**Status as of last Weekly Progress Report 5/4/16 *immediately following termination of Extraction System***

ST12 Steam Enhanced Extraction: Has criteria for termination of Steam Injection Been Met?

## Weekly progress report 5/4/16: UWBZ

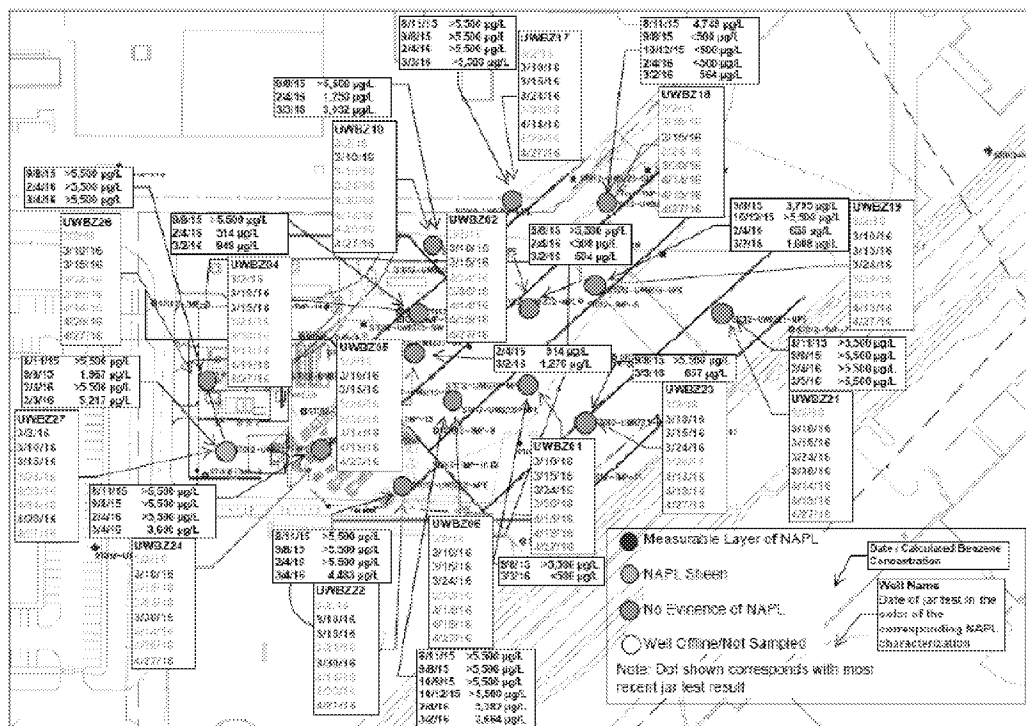
**Extraction system was still effectively removing LNAPL at time it was shut down. Benzene Concentrations in UWBZ still exceed 500 µg/L; Criteria has not been met for UWBZ**

Figure 4. Daily Mass Removed

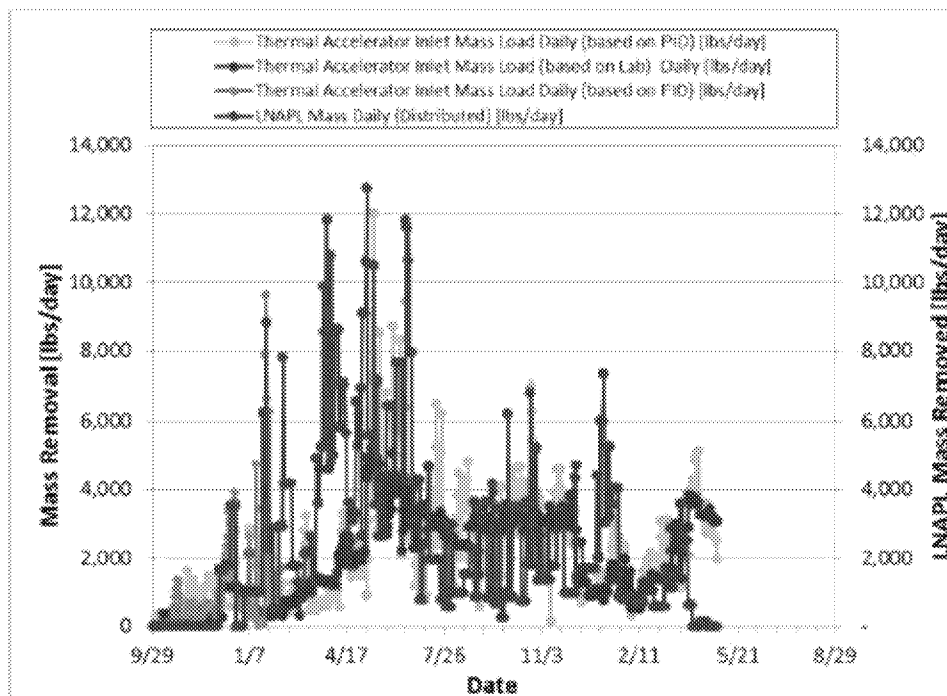
**Analysis:** Vapor recovery alone was at more than 3000 lbs per day, up to 25% of peak removal rate; Criteria for termination of steam injection has not been met. Figure indicates

**daily LNAPL recovery rate has dropped off only due to termination of steam injection, However the tally in the weekly reports show that 35,254 gallons of LNAPL were recovered between the week the steam injection system was shut down and the extraction system terminated, and there was still LNAPL being recovered at the time the extraction system was shut down.**

Figure 6. Average Soil Temperatures

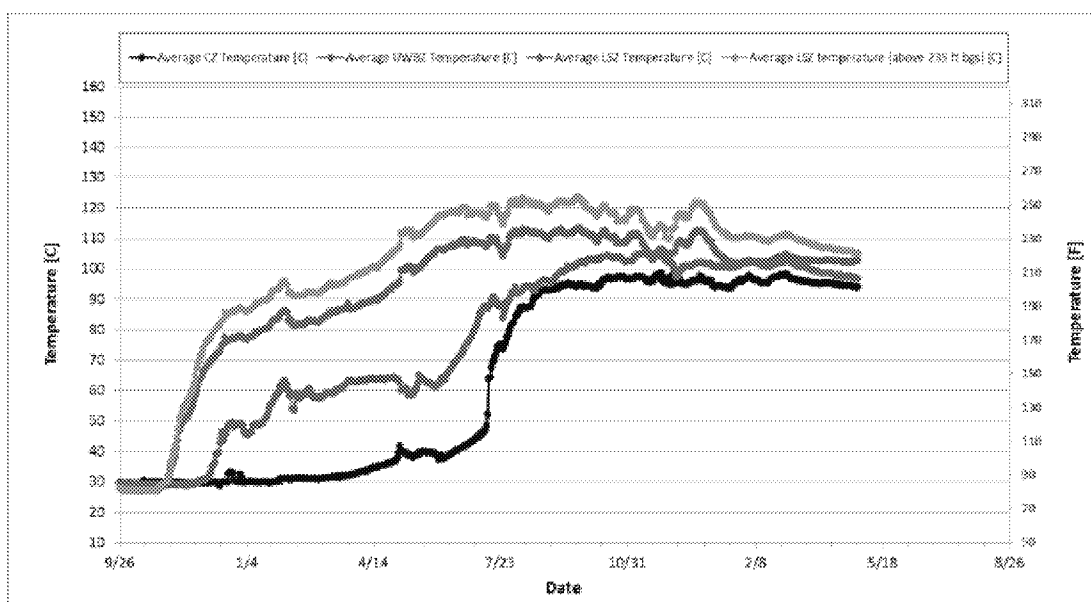
***Soil temperatures starting to decline a time extraction system was shut off and no longer a mechanism to cool the site down, the concern now is that hot mobile contaminants will spread if not contained.***
